From: Jamie Barton [JBarton@phd1.idaho.gov]
Sent: Friday, January 27, 2012 1:01 PM
To: Edl, Michele
Subject: RE: information request Nothern Lights PWS# 1090243
Attachments: 2000 survey report.pdf; Well and mechanical room plans.pdf; Engineer letter.pdf; Site plan.pdf; Northern Lights.pdf; Northern Lights Survey9-08 .pdf

DRINKING WATER SUPPLY REPORT

Attn: Gary J. Gaffney, P.E.
Subj: Northern Lights Inc., Headquarters Facility Water System in Sagle
Ref: Revised As-built Plans

Drinking Water Supply Report September 25, 2008

Looking in reservoir through access riser

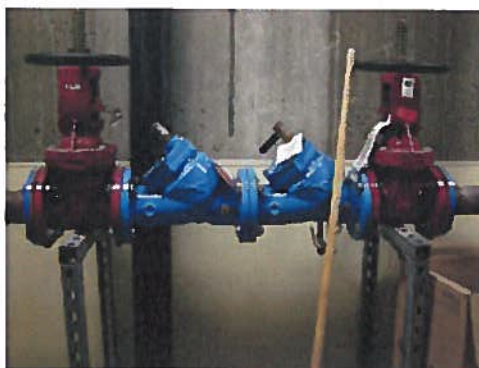
The reservoir has not been cleaned or inspected since the year 2000 when it went into service. At the time of the survey, a layer of film was evident on the walls of the reservoir and on the water, which provides an environment for bacterial growth. It is highly recommended to have the reservoir drained and cleaned at least every five years.
